## Meeting of the Upper Thames River Conservation Authority Hearing Committee – Agenda

### **5. Application #50-24**

Proposed Development within an area regulated by the Upper Thames River Conservation Authority at 952 Southdale Road West, London

**To: Chair and Members of the UTRCA Hearing Committee**  
**From: Michael Funk, Land Use Regulations Officer**  
**Date: May 28, 2024**  
**File Number: HC-05-24-05**  
**Agenda Number: 5**  
**Subject: Section 28 Permit Application #50-24 for Proposed Development within a Riverine Flood Hazard and Wetland Area of Interference Regulated by the Upper Thames River Conservation Authority at 952 Southdale Road West, City of London, Ontario**

Title  
PROPOSED FLOODPLAIN ADJUSTMENT  
PLAN VIEW

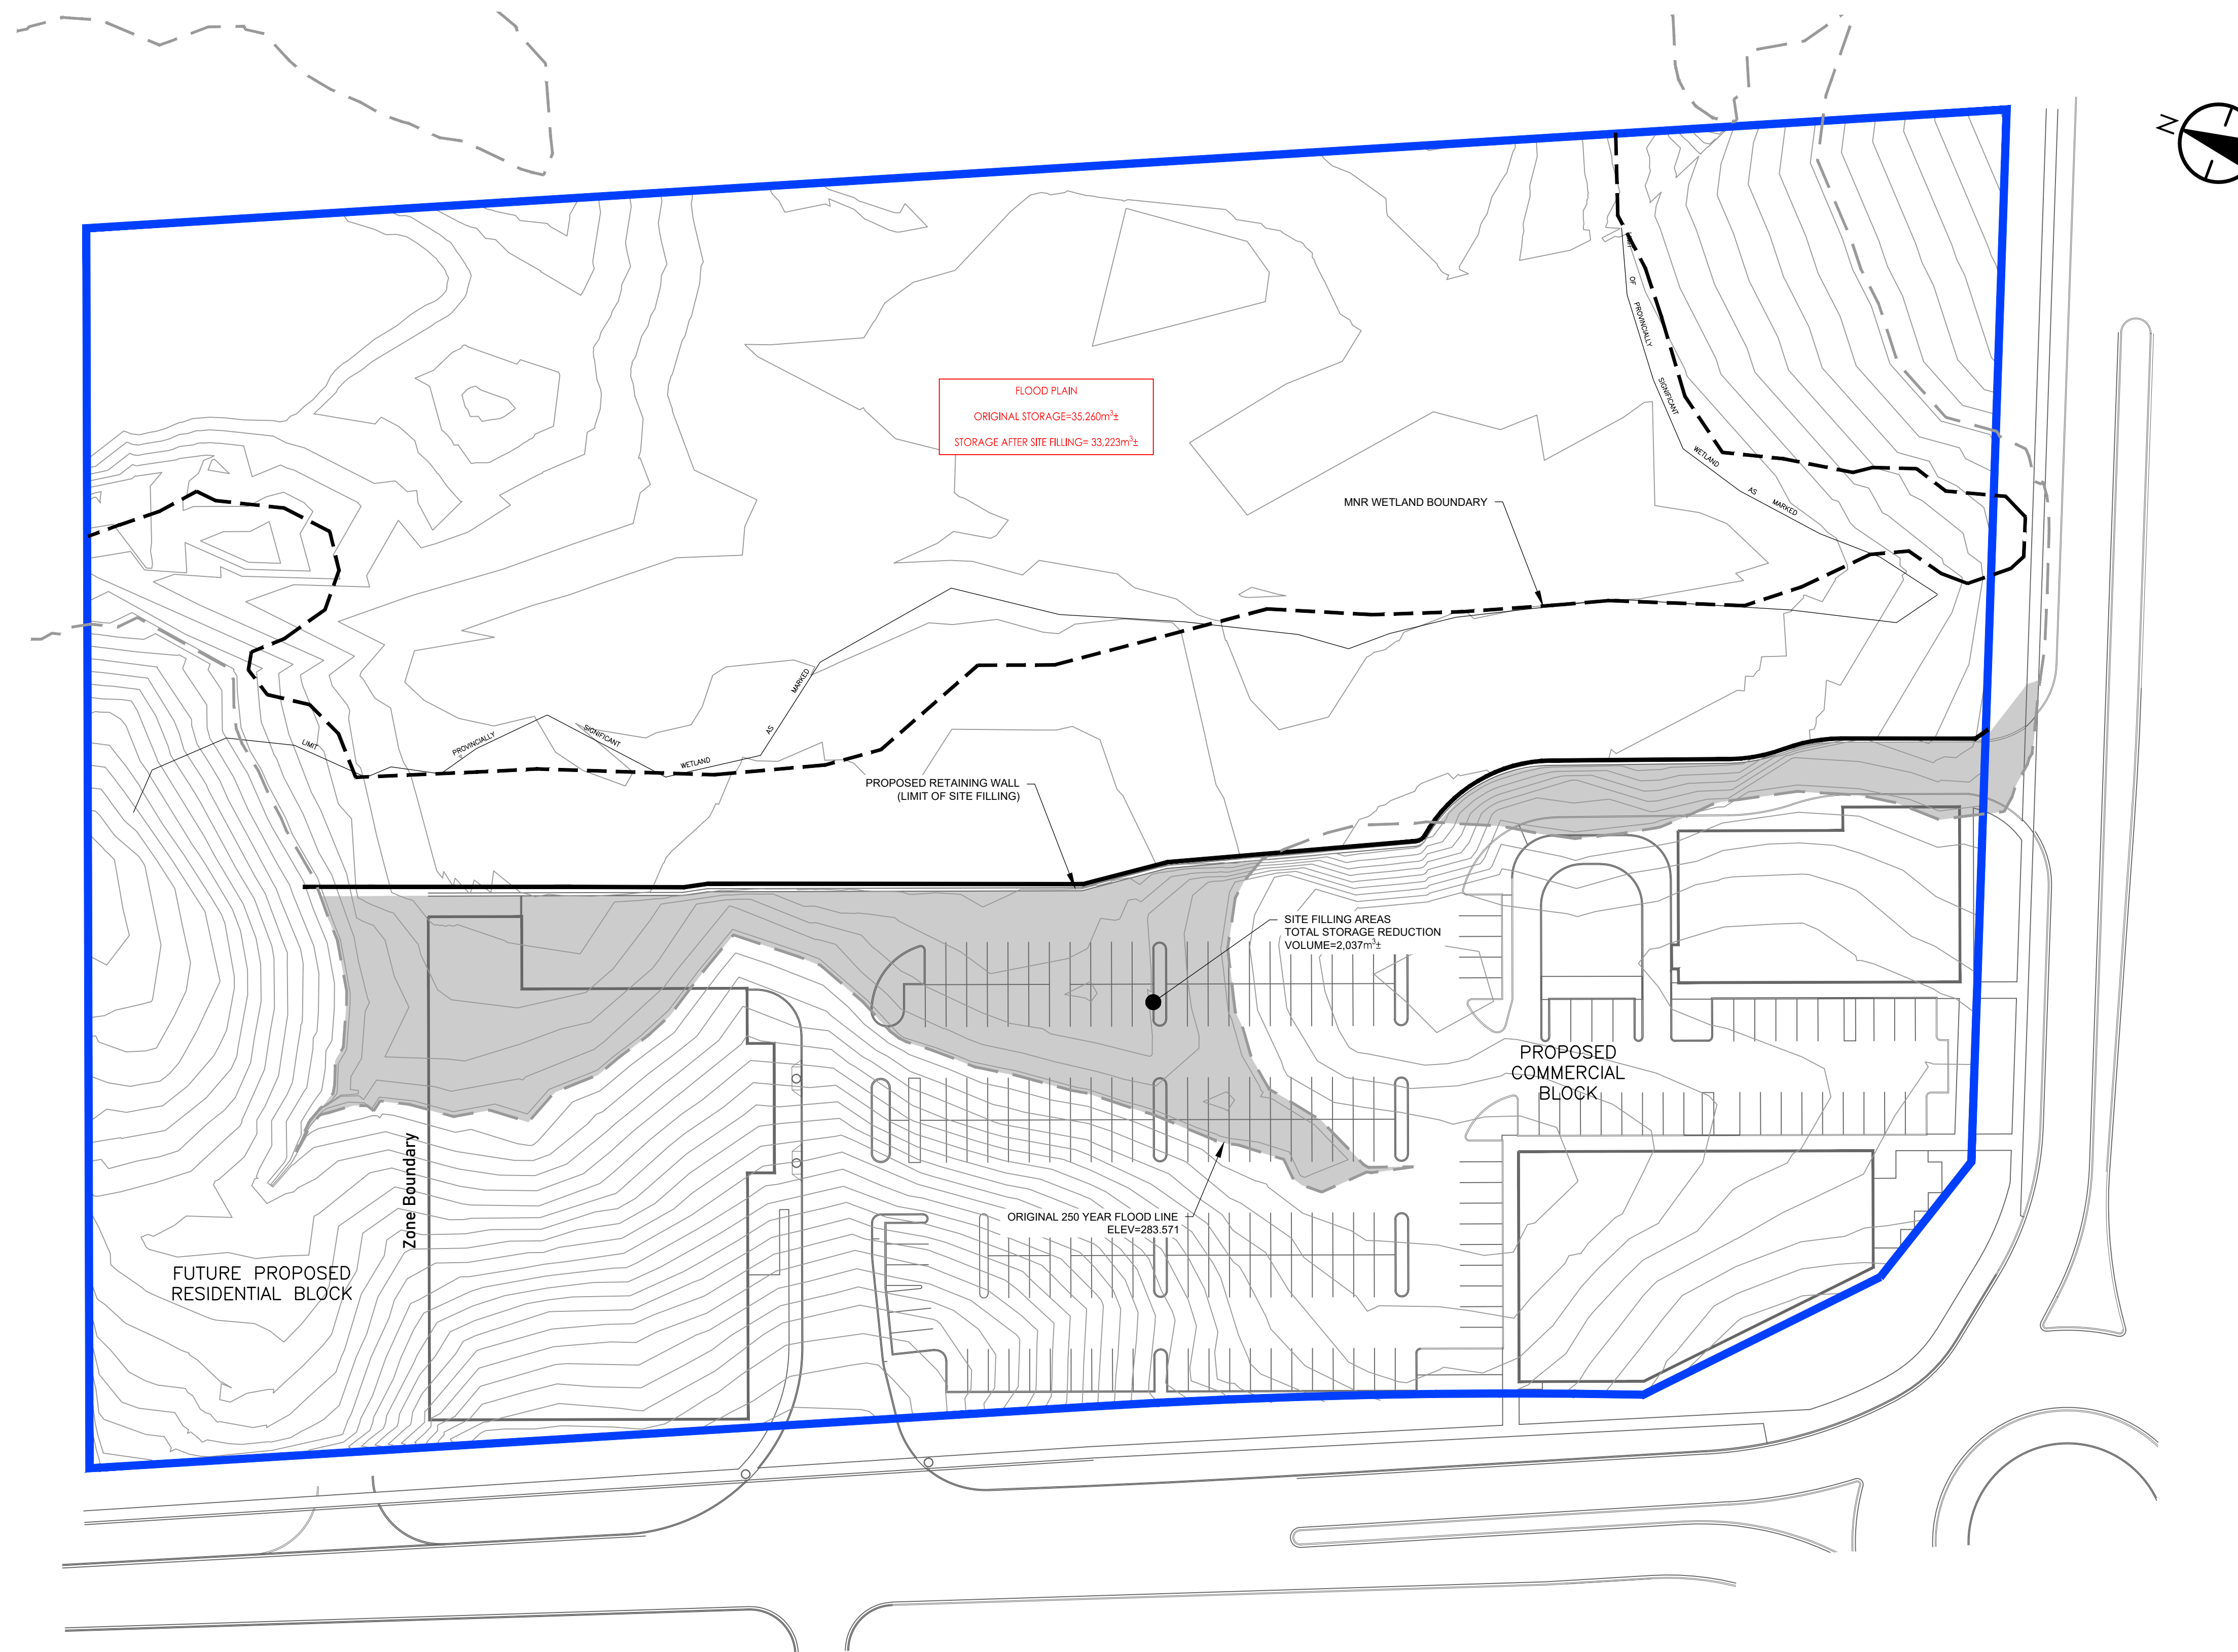
As shown on the attached Proposed Floodplain Adjustment Drawing, the latest site plan requires filling to occur on the existing floodplain, resulting in the loss of 2,037 m<sup>3</sup> of flood storage. This filling is to occur on what was actively farmed land and is not occurring anywhere within the existing wetland or the proposed buffers. This filling area is shown on the attached figure.

- SITE BOUNDARY
- AREA REMOVED FROM FLOODPLAIN  
REMOVED AREA = 3363sq.m  
FLOOD PLAN VOL. LOST= 2036cu.m
